CITY OF NEWTON, MASSACHUSETTS

Department of Planning and Development

SUBJECT: #214-10 NEW ENGLAND DEVELOPMENT LLC/NED CHESTNUT HILL SQUARE LLC/G&K LLC/KEY CHESTNUT LLC petition for a change of zone to *Business 4* for parcels located at 200-230 Boylston Street also identified as Section 82, Block 2, Lots 10, 14, 15, 15A, 15B, 15C, 29, 30, 8, 9, 18, currently zoned Business 1, Lot 11, currently zoned Limited Manufacturing, and 13 and 32, currently zoned Multi Residence 2.

#215-10 NEW ENGLAND DEVELOPMENT LLC/NED CHESTNUT HILL SQUARE LLC/G&K LLC/KEY CHESTNUT LLC petition for a SPECIAL PERMIT/SITE PLAN APPROVAL to construct a mixed-use retail and residential development, including an 8-story building containing 91 residential units, approximately 102,000 sq ft of retail (with open air businesses) and restaurant space (over 50 seats), a 60,000 sq ft medical office building, 30,000 sq-ft health club and waivers from associated parking requirements, including but not limited to a multi level parking facility, driveway width in excess of 25', valet parking, dimensions for handicapped parking stalls, retaining walls of greater than 4' in setbacks, and additional freestanding signs; numbe

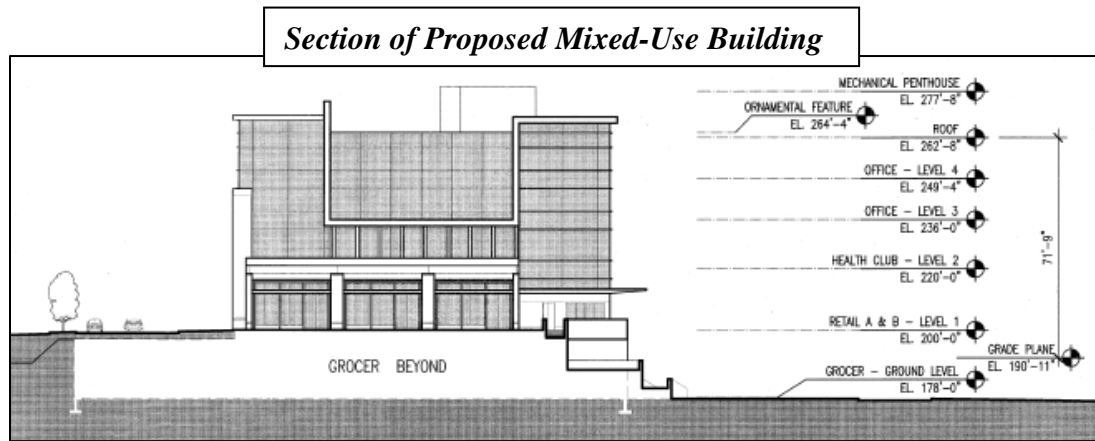
As proposed, none of the retail or restaurant spaces in Building C have entrances from Boylston Street and the Planning Department is concerned that this design will not lead to an active streetscape along this prominent façade. The Planning Department has continuously encouraged the petitioners to consider breaking up the linear mass of the building with a mid-building pedestrian cut-through and/or entrances to the retail/restaurant uses from the Boylston Street side. The petitioners have responded that they do not anticipate significant pedestrian traffic along Boylston Street and that breaking up the mass would result in a loss of rentable space and limits the marketability of the retail space. Furthermore, the petitioners have stated that for security reasons retail tenants do not prefer double entrances.

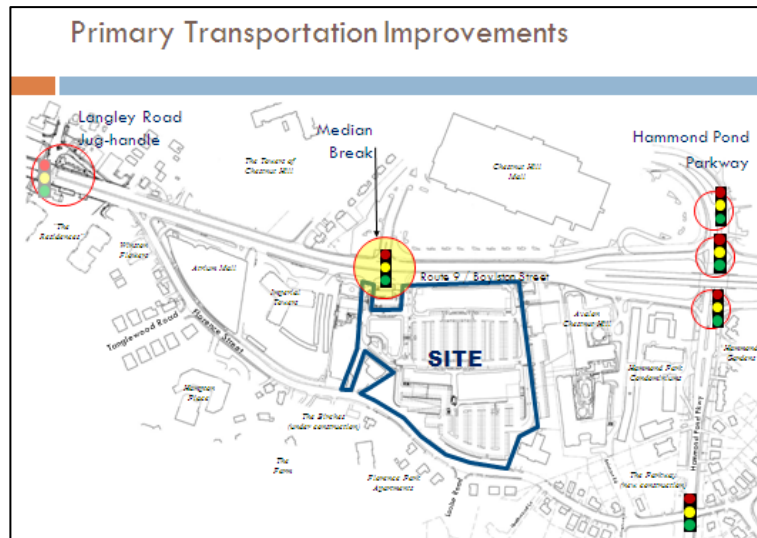
Currently, the proposed grocery store and parking area for this portion of the site face Florence Street. The Planning Department believes the development could provide a more successful transition to the neighborhoods on Florence Street and the neighboring Town of Brookline. Earlier iterations of the site plan showed vehicular access to Florence Street for the proposed residential component that was oriented towards this street. The orientation of residential-facing-residential buildings seemed like a more fitting transition towards the commercial uses and Route 9.

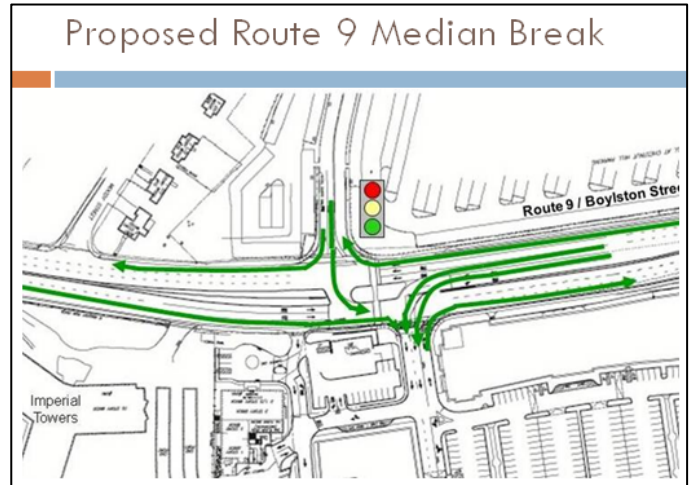
Route 9: Installation of a median break along Route 9 at the primary (center) entrance of the project site, widening of both Route 9 approaches to accommodate three travel lanes per direction and two westbound left-turn lanes to serve the project.

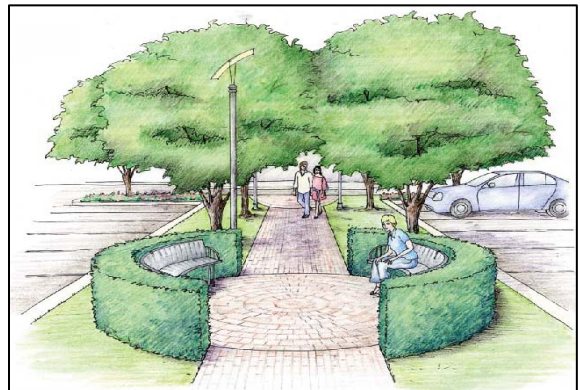
The petitioners are proposing retaining walls around portions of the perimeter of the site. Due to the site’s topography, some sections of these walls exceed four feet in height and are located within setbacks; therefore, the petitioners need a special permit for such proposed conditions. Most of the proposed walls are low except for the southwest corner where a 17 foot retaining wall separates the residential building (Building D) and the retail building and structured parking (Building B) from an adjacent three-story condominium building that is not part of the project site. As the condominium building sits at a much lower elevation than the adjacent project site, the creation of such a retaining wall may significantly impact these residents unless properly screened. Finally, the adjacent condominium property already has a retaining wall with a fence on top and the creation of an additional wall creates a vacant valley that is difficult to access and may collect waste. Should the Board choose to approve this petition, the Planning Department recommends the Board consider a condition that ensures the petitioners will remove any trash that may accumulate from this portion of the site at least semi-annually. The retaining walls are proposed to be precast modular block and the petitioners should submit a detail of the proposed walls prior to Working Session.

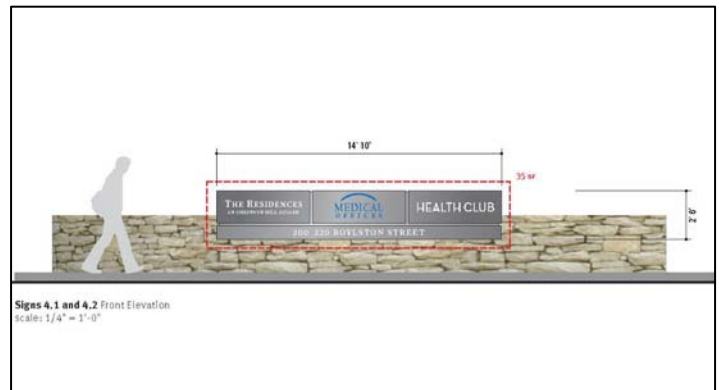
In response to the Chief Zoning Code Official's review, the petitioners have revised proposed freestanding signs to be eligible for special permit relief. The petitioners are now proposing two freestanding signs at the Boylston Street entrances. Proposed signs are low (2½-feet) and have stone bases. These signs meet the maximum 35 feet size limit of the signage requirements. The petitioners are proposing eight three-sided directional kiosk signs which the Planning Department thinks could be reduced in number so as not to clutter up the site, particularly given their size which is proposed as 7'-9" by 4'-0".
